Project: 08-29 NIKE LIVE - CARY, NC
System/Unit: FAN - Supply

Project Issue Information

Issue Name : SF1

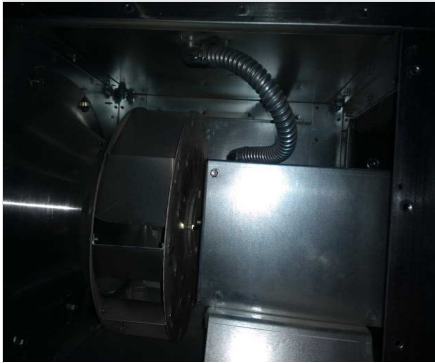
Description : EMS HAS NO CONTROL OVER FAN SPEED, THEIR SYSTEM SAYS SF1 FAN WAS NOT RUNNING WHEN FAN WAS RUNNING 100%. THERE IS NO SPEED CONTROLLER INSTALLED ON FAN. FAN BLADES ARE ALSO GRINDING REALLY BAD, FAN WAS SHUT OFF TO PREVENT DAMAGE FROM OCCURRING. THESE ISSUES WILL NEED TO BE RESOLVED BETWEEN EMS AND MECHANICAL FIELD TECH WHO INSTALLED CONTROLS.

- **08/31/2022** **National TAB - Andrew Loignon**
 - SF1 IS OPERATIONAL, HOWEVER COMFORT CONTROL SYSTEMS CAN NOT ADJUST FAN SPEED THROUGH THEIR SYSTEM DUE TO FAULTS, RESULTING IN SF1 NOT BEING ABLE TO BE BALANCED CAUSING OA FOR FCU 1-4 TO BE ABLE TO BE BALANCED
